Re: SO₂ Area Designation for Labadie Energy Center

Re: Comments on Ameren Missouri's Labadie Sulfur Reduction Project Quality Assurance Project Plan

Re: 2015 Monitoring Network Plan

Figure 1. Augusta SO₂ monitors in relation to DNR's modeled peak concentration areas.

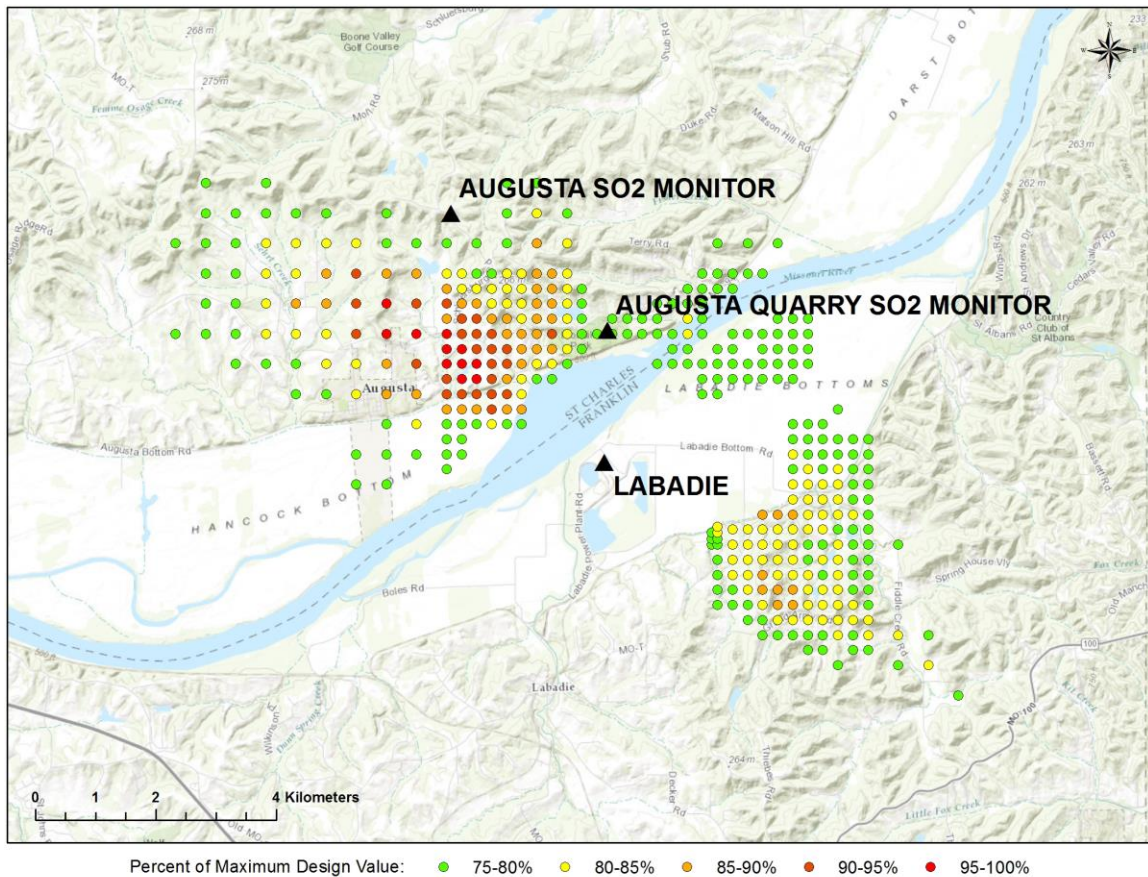
Second, monitoring data from the long-inactive Augusta and Augusta Quarry SO₂ monitors similarly fail to undermine the nonattainment designation required by DNR's modeling. There is no indication that either of those monitors was sited in areas of expected peak concentrations caused by the Labadie plant's emissions. To the contrary, DNR's modeling indicates that they were not sited in areas of expected peak concentrations associated with Labadie's emissions. This is shown in Figure 1, below.

Furthermore, the data from the Augusta monitors reveal high 1-hour SO₂ concentrations, with consistent violations of the NAAQS. The Augusta monitor operated from July 1, 1987 until December 19, 1994. The design values for every three-year period during the monitor's operation were well above the 1-hour SO₂ NAAQS – ranging from 259 ppb for 1987-1989 to 114 ppb for 1992-1994.¹⁸ The Augusta Quarry site operated for three full years (1995-1997) and portions of two additional years (1994 and 1998). The design value for the only complete three-year period was 78 ppb, exceeding the 1-hour SO₂ NAAQS. The fourth-highest one-hour readings during two of the three complete data years were well above the 1-hour SO₂ NAAQS (86 ppb in 1995 and 80 ppb in 1997).¹⁹

Figure 2. Alternative nonattainment area boundary based on Spirit of St. Louis Airport meteorological data.

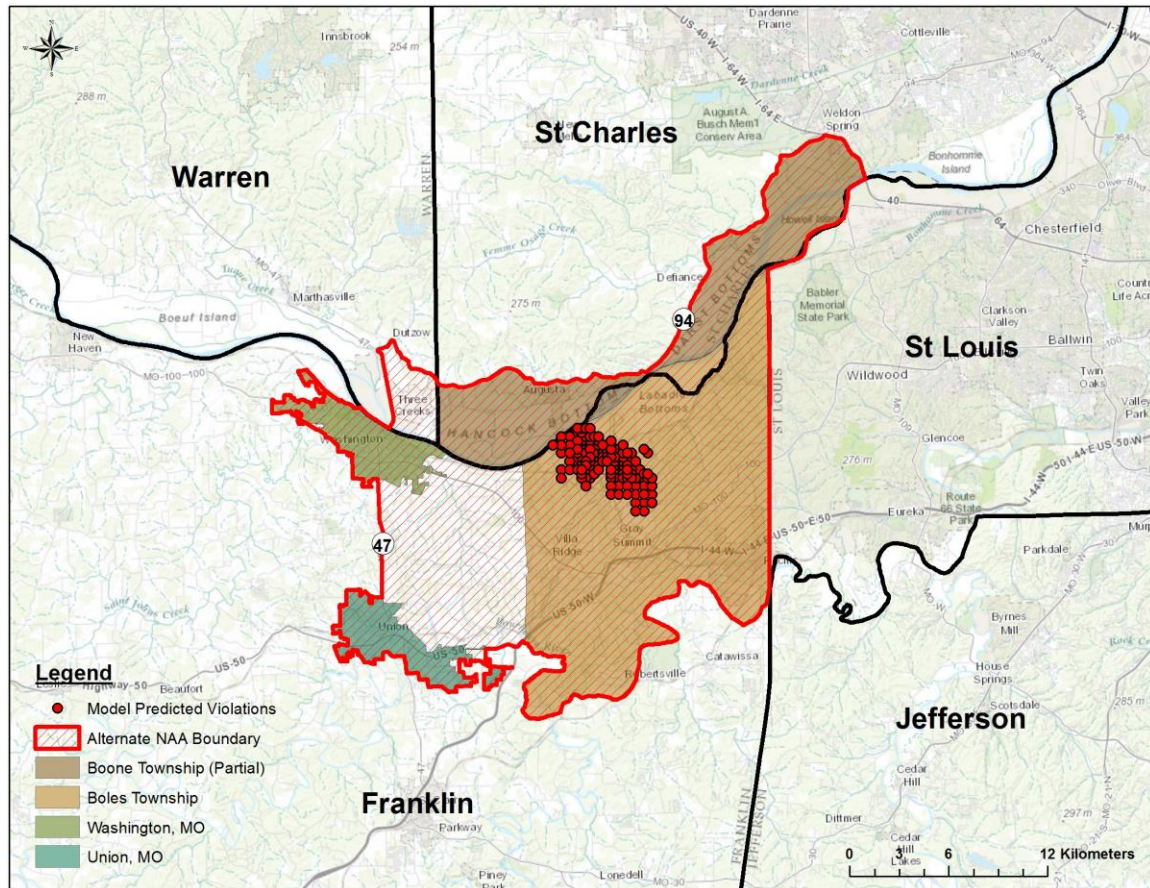
Alternatively, DNR should consider modifying the proposed boundaries of the nonattainment area to encompass a larger portion of northeast Franklin County, which DNR's modeling suggests encompasses most if not all modeled violations when potentially more representative meteorological data from the Spirit of St. Louis Airport in Chesterfield is used.³⁰ With Spirit of St. Louis Airport meteorological data, the locus of modeled violations shifts to the south and southwest of the plant. A more appropriate nonattainment area boundary based on these modeled violations would encompass Boles Township, a small portion of Boone Township (south of

Missouri Highway 94), and the area west of Boles Township bounded by Missouri Route 47 and the municipal boundaries of Washington and Union, Missouri. This is shown in Figure 2, below.

Figure 1. Receptors with modeled design values 75 percent of the maximum design value.

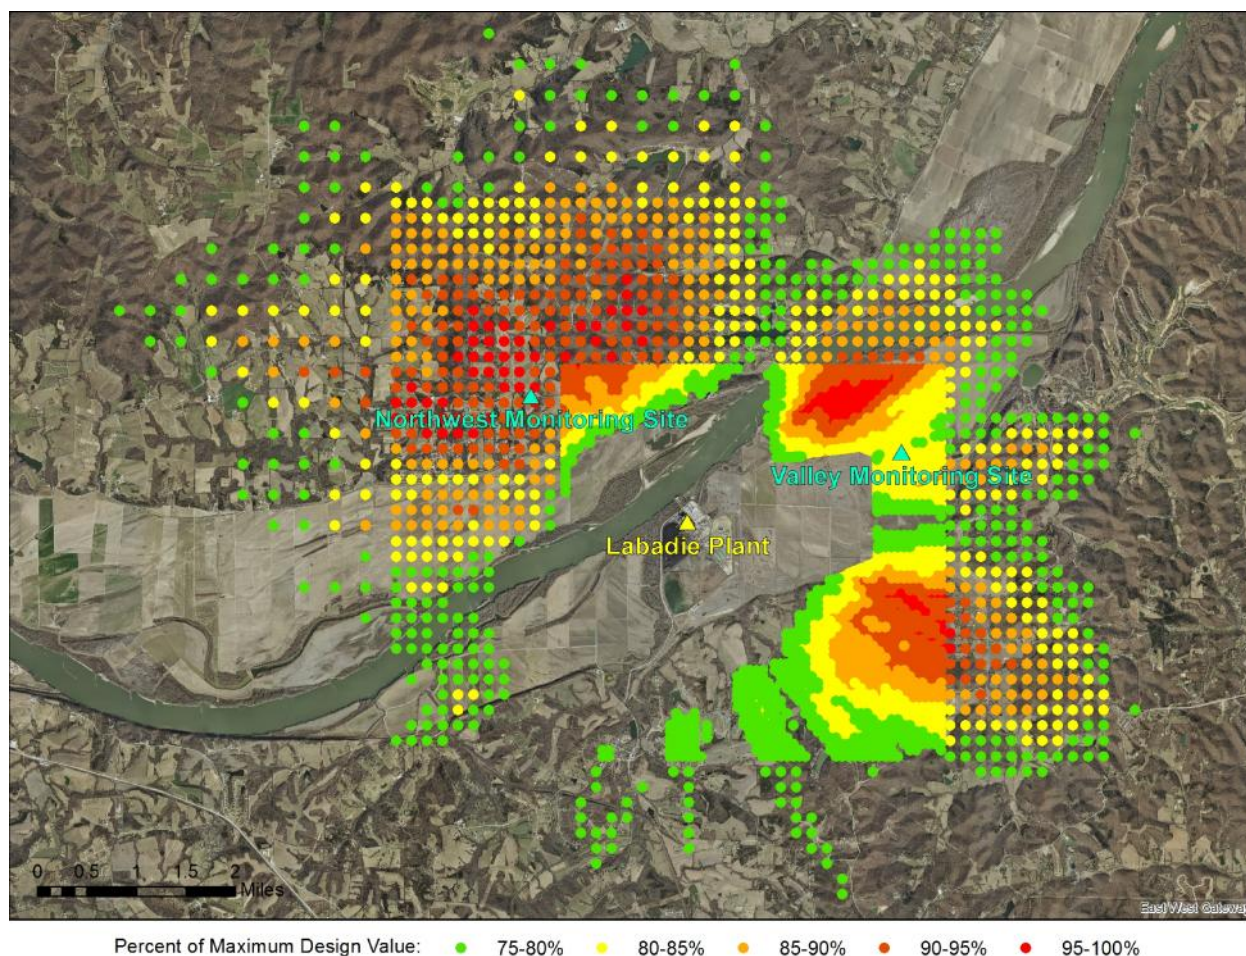
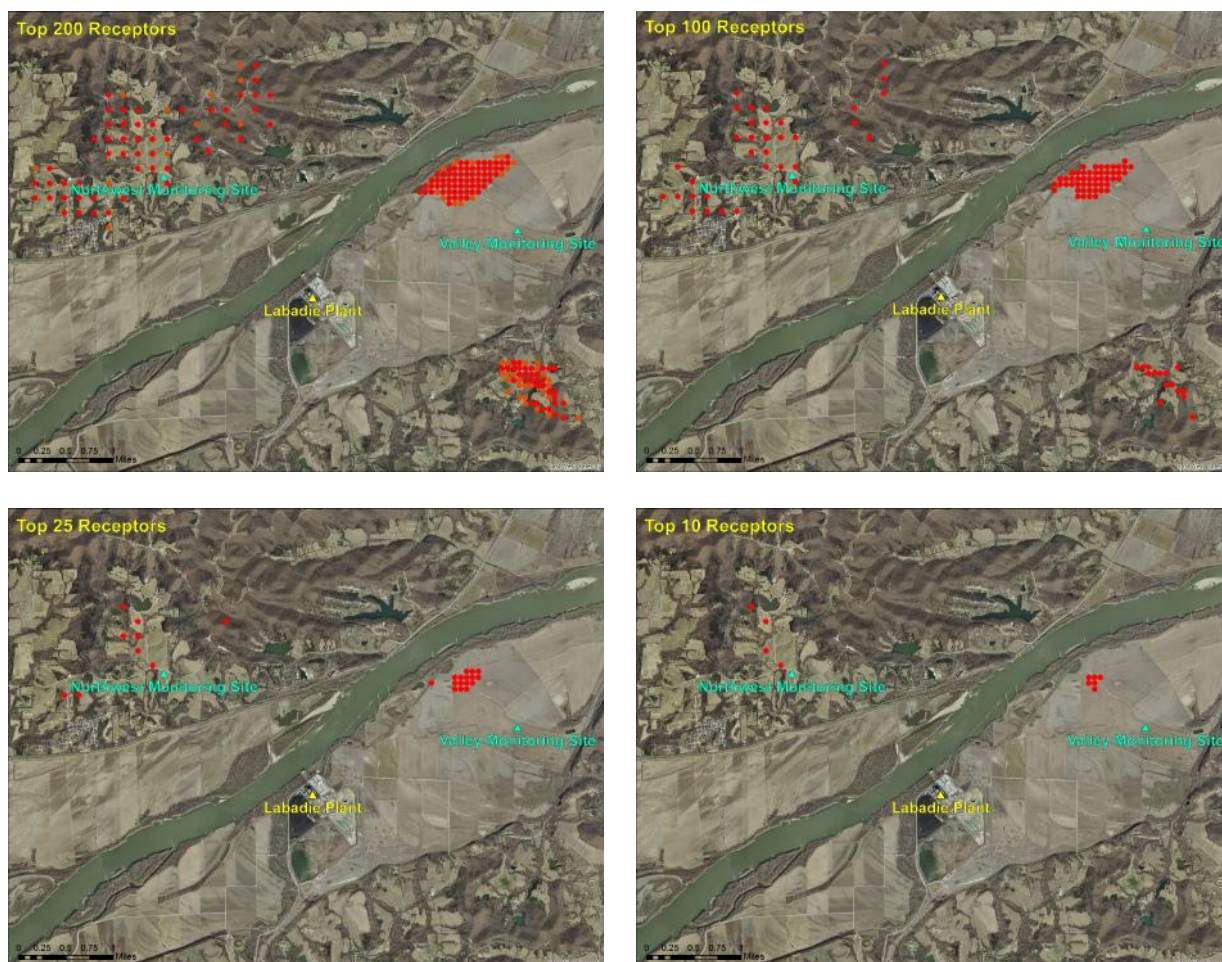
Figures 1 and 2 reveal three distinct areas where modeled design values are in excess of 95 percent of the maximum modeled design value and where the majority of the top 200 receptors (and all of the top 100, 25 and 10 receptors) lie. These areas, located northwest, northeast, and southeast of the Labadie Energy Center, are where the modeling predicts peak 1-hour SO₂ concentrations are expected to occur. Furthermore, although a rigorous comparison is not possible without detailed receptor data, a simple visual comparison of Figures 1 and 3 indicates that the areas where peak 1-hour SO₂ concentrations are expected to occur (i.e., where modeled design values are in excess of 95 percent of the maximum modeled design value) overlap with the areas where daily maximum 1-hour SO₂ concentrations most frequently exceed 75 percent of the maximum modeled design value. Monitoring stations located in these areas would have the greatest chance of identifying peak SO₂ concentrations in ambient air, which is the primary objective of source-oriented monitoring and an absolute necessity when monitoring to assess compliance with the NAAQS.

Figure 3. Number of maximum daily 1-hour SO₂ concentrations at each receptor that exceed 75 percent of the maximum modeled design value.

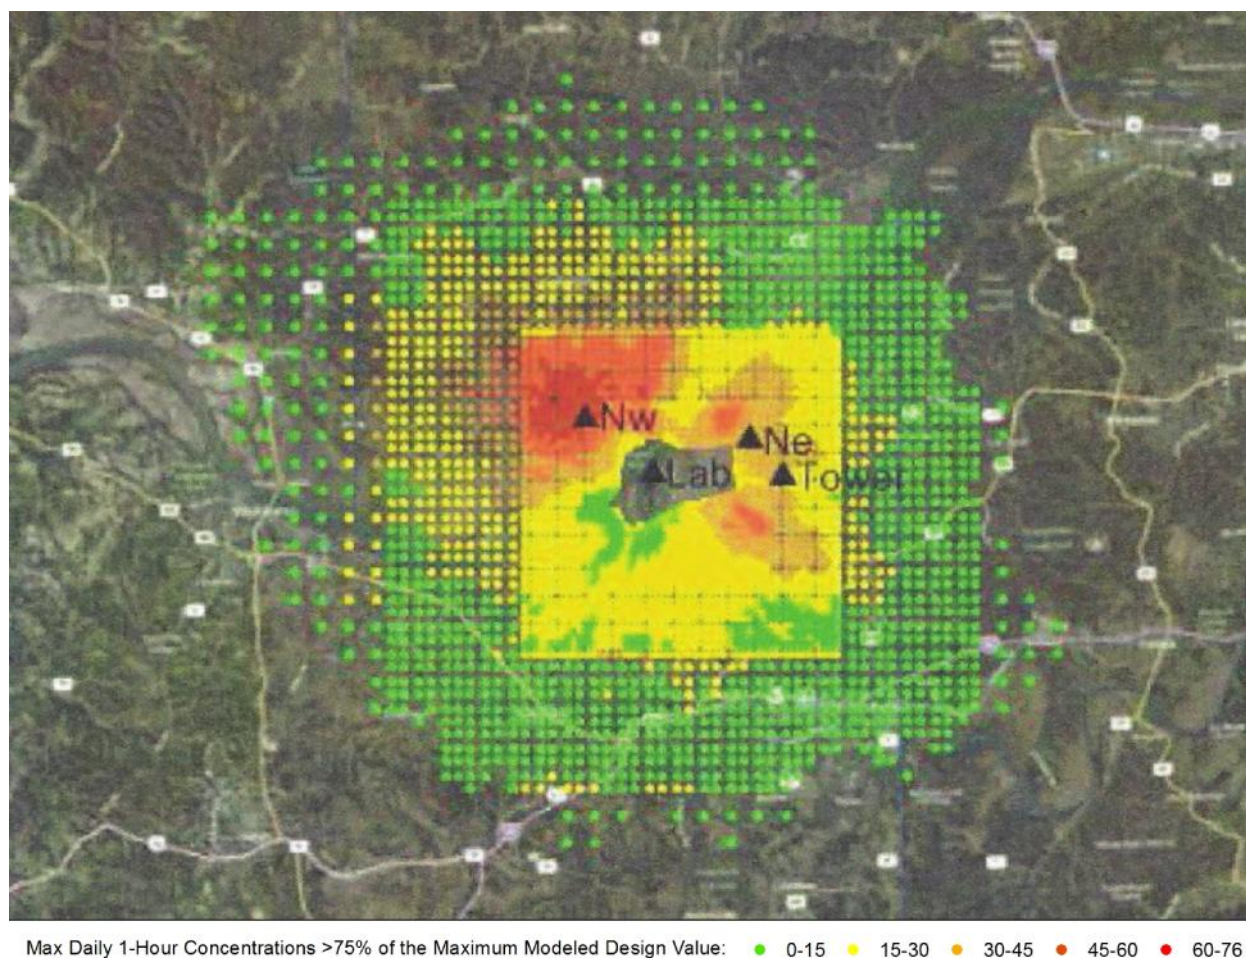
However, only one of Ameren's proposed monitoring sites, the northwest site, is located in one of the three peak concentration/high frequency areas predicted by the modeling (the one located northwest of the plant). No monitoring sites are proposed in the peak concentration/high frequency areas located northeast or southeast of the plant. Instead, Ameren's only other proposed monitoring site, the valley site, is located in an area where modeled design values are only about 80 percent of the maximum modeled design value and where daily maximum 1-hour SO₂ concentrations exceed 75 percent of the maximum modeled design value about half as often as they do in areas where this occurs with the greatest frequency. This makes the valley site an inappropriate site for a monitor to assess compliance with the NAAQS. Ameren's modeling predicts that ambient SO₂ concentrations will be as much as 25 percent higher in several areas around the plant than they will be at the valley site, meaning a monitoring station at the valley site could be in compliance with the NAAQS while significant violations were occurring nearby.

The QAPP states that a monitor could not be sited in the peak concentration/high frequency area northeast of the plant because it is an actively farmed area, physical access is almost impossible

without building additional infrastructure, and electric power is not available. These justifications do not stand up to the barest scrutiny. The entire Labadie Bottoms is an actively farmed area, accessible only by unimproved roads that severely limit vehicular access during wet weather conditions. As such, the proposed valley monitoring site is no more accessible than a site within the peak concentration/high frequency area northeast of the plant would be, and additional road infrastructure will likely be necessary for all-weather access regardless of where in the Labadie Bottoms the monitor is located.⁴ Furthermore, electric power is not available anywhere within the Labadie Bottoms, including at the proposed valley monitoring site. Therefore, distribution infrastructure will have to be built to deliver power to any monitoring site in the Labadie Bottoms regardless of where it is located. The St. Albans Water and Sewer Authority/Franklin County PWSD #3 wastewater treatment facility, located approximately 1 kilometer east of the proposed valley monitoring site, appears to be the closest available source of electric power for monitoring sites in the Labadie Bottoms, and only a minimal amount of additional line would be necessary to deliver power to a monitor located in the peak concentration/high frequency area northeast of the plant compared to one located at the proposed valley monitoring site.

- 1) Relocate the proposed valley monitoring site to the peak concentration/high frequency area northeast of the plant; and
- 2) Add a third monitoring site in the peak concentration/high frequency area southeast of the plant.

Figure 1. Modeled peak concentration areas near Ameren's Labadie plant.

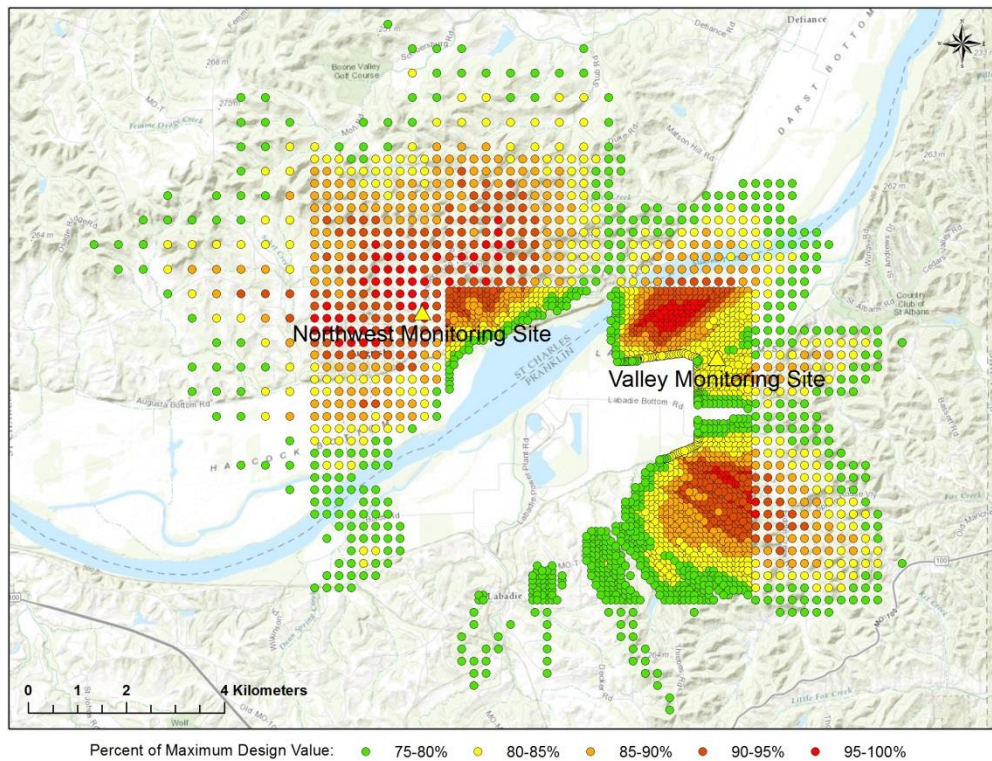
In our April 13, 2015 comments to DNR on Ameren’s proposed new Labadie monitoring sites, attached as Exhibit 1, we demonstrated that one of the proposed sites – the Valley site – is not located in any of the areas where Ameren’s modeling predicts peak SO₂ concentrations are expected to occur. Ameren’s modeling identified three distinct areas where the highest SO₂ concentrations are expected to occur and where high concentrations are expected to occur most frequently. These areas are located northwest, northeast, and southeast of the plant and are shown in Figure 1 below. However, only one of the two proposed Labadie monitoring sites – the Northwest site – is located in one of these peak concentration areas (the one located northwest of the plant). The Valley site is located between the other two peak concentration areas, in an area where the modeled concentration is only about 80 percent of the maximum concentration predicted by the model. As a result, it is unlikely to capture maximum ambient SO₂ concentrations and should be relocated to the peak concentration area northeast of the plant.

In addition, DNR should also require the installation of a third monitor in the peak concentration area southeast of the plant lest anticipated maximum ambient SO₂ concentrations in this area – which are likely to have implications for NAAQS compliance – go undetected by the Labadie SO₂ monitoring network.

Figure 5. Ameren's proposed SO₂ monitoring sites relative to DNR's polygons. Peak concentration areas (>90 ug/m³) are shaded red.

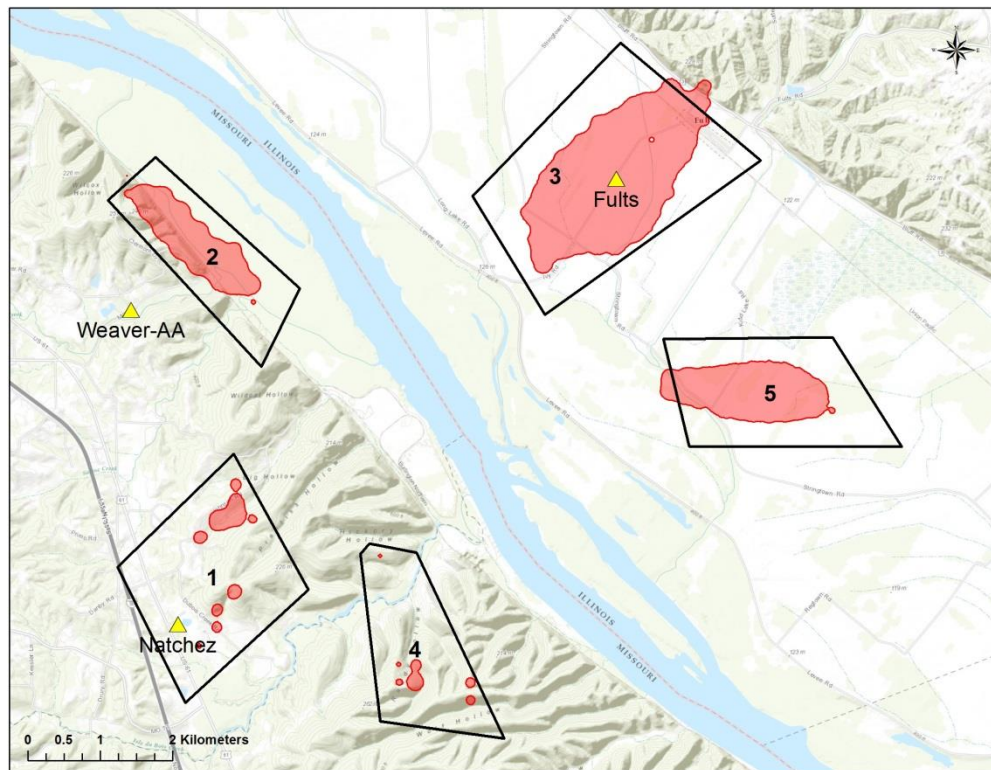
The locations of Ameren's proposed SO₂ monitoring sites – dubbed Fults, Natchez and Weaver-AA – relative to DNR's polygons are shown in Figure 5 below. Of the three proposed sites, only the Fults site, which is inside the peak concentration area within polygon 3, is properly located. The Weaver-AA site, which Figure 2 of Monitoring Network Plan Appendix 5 incorrectly shows being within polygon 2, is actually located outside of it based on the site coordinates provided in Plan Appendix 1. Hence it is not properly located. Nor is the Natchez site, which should be located within polygon 5 instead of polygon 1 because polygon 5 has higher modeled impacts.

Because they are not properly located, neither the Natchez nor Weaver-AA monitoring sites will adequately represent Rush Island's SO₂ air quality impact. Therefore, both sites should be relocated. The Weaver-AA site should be located inside the peak concentration area within polygon 2 and the Natchez site should be located inside the peak concentration area within polygon 5 as shown in Figure 6 below. Alternatively, the Natchez site could be moved inside the peak concentration area within polygon 1 and a fourth monitor added inside the peak concentration area within polygon 5 as shown in Figure 7 below. The recommended monitor locations shown in Figures 6 and 7 are easily accessible and appear to meet EPA siting criteria and have ready access to power.
